IN THE UNITED STATES PATENT AND TRADEMARK OFFICE

Applicant: Marocco, Norbert
Serial No: 09/814,261
Filed: March 21, 2001
Title: SINGLE PLATE CUT DOWN APPARATUS
Examiner: Prone, Jason D.
Art Unit: 3724
Docket No.: 625.0006USQ
Customer No.: 27623

ANNOTATED SHEET SHOWING CHANGES MADE

FIG. 9

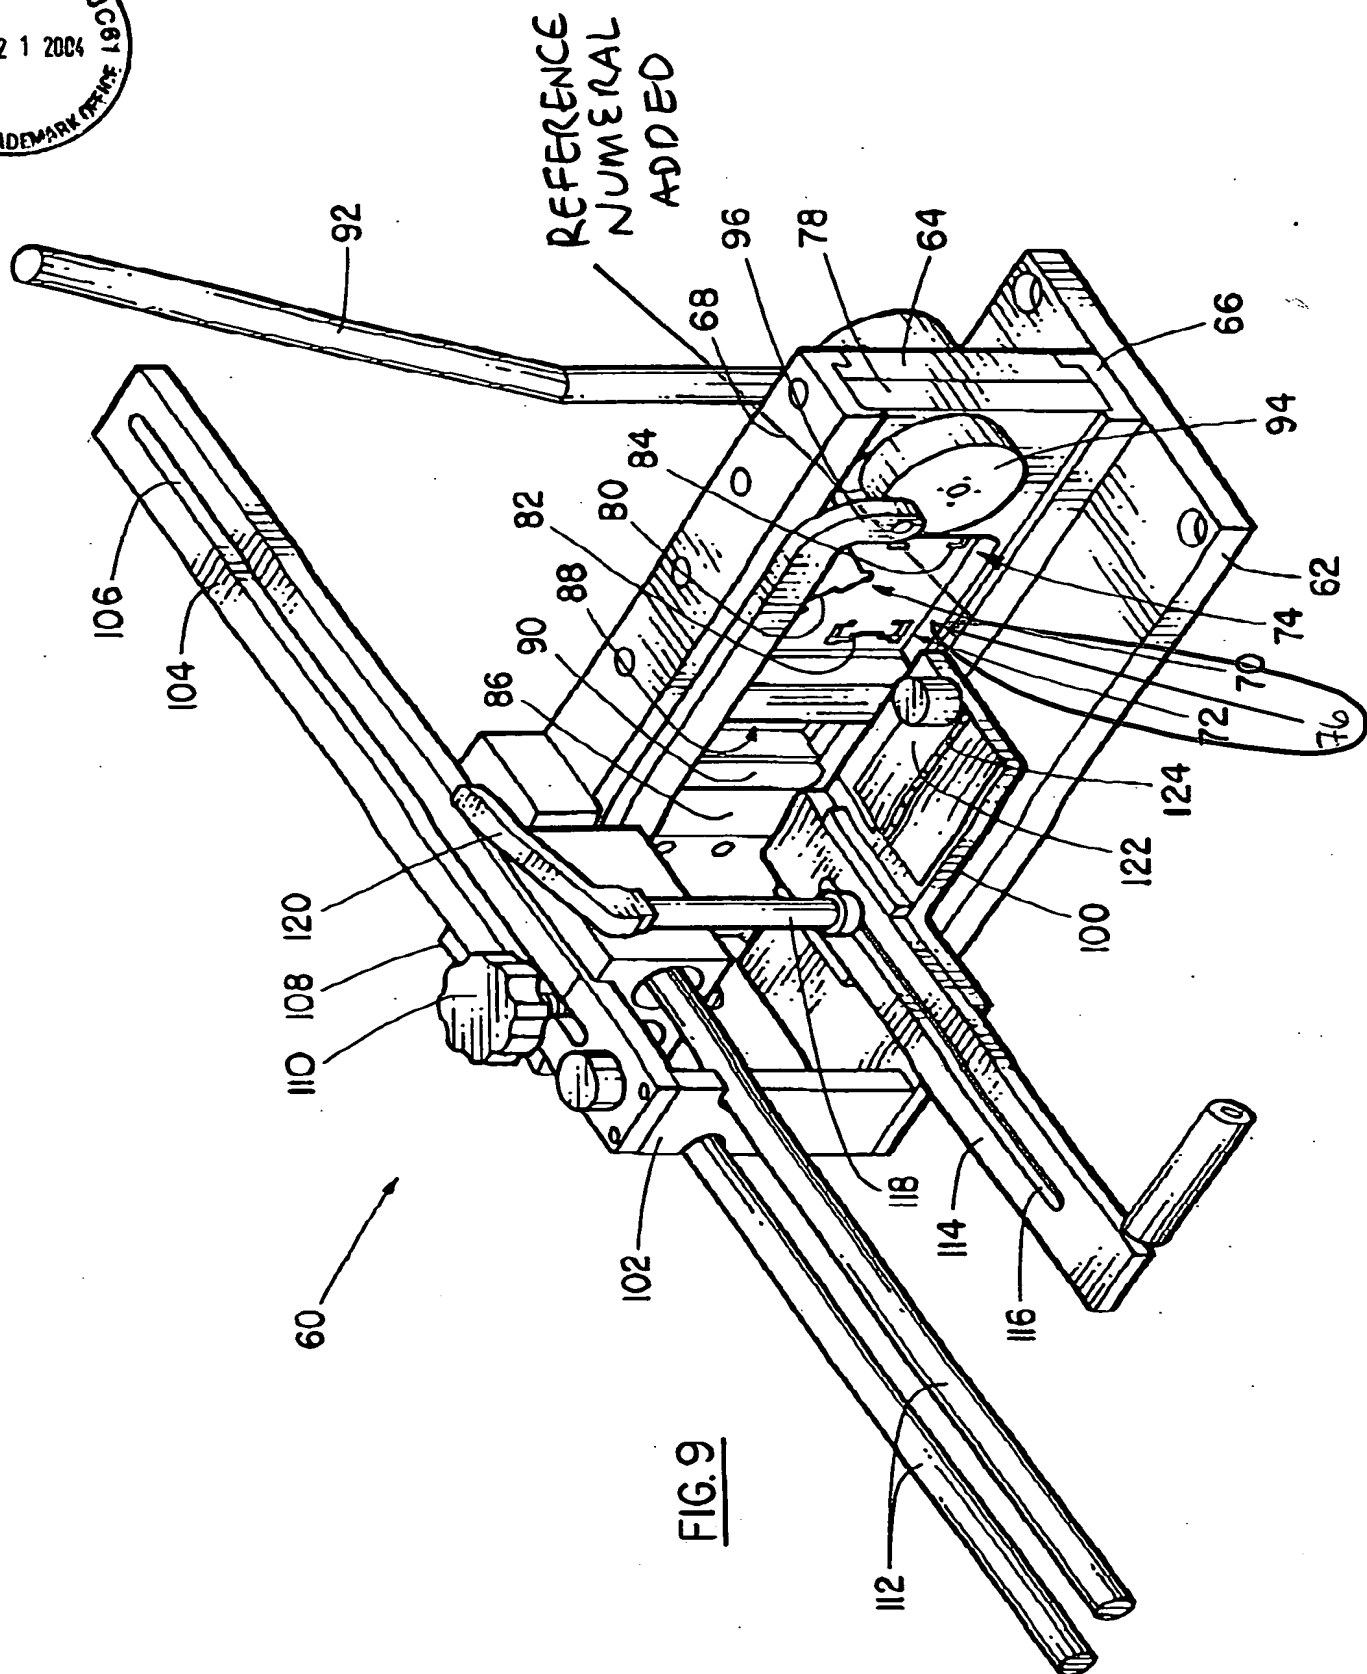
In the Action, the drawings were objected to as failing to comply with 37 C.F.R. § 1.84(p)(5) because reference numeral "76" was omitted from the drawings. Applicant has added previously omitted reference numeral "76" to proposed Figure 9. Reference numeral "76" was disclosed in the specification at page 10, line 11. No new matter has been added to the application. As requested by the Office, applicant requests authorization to submit final corrected drawings showing the proposed corrections as indicated. Reconsideration and withdrawal of the 37 C.F.R. § 1.84(p)(5) rejection are respectfully requested.
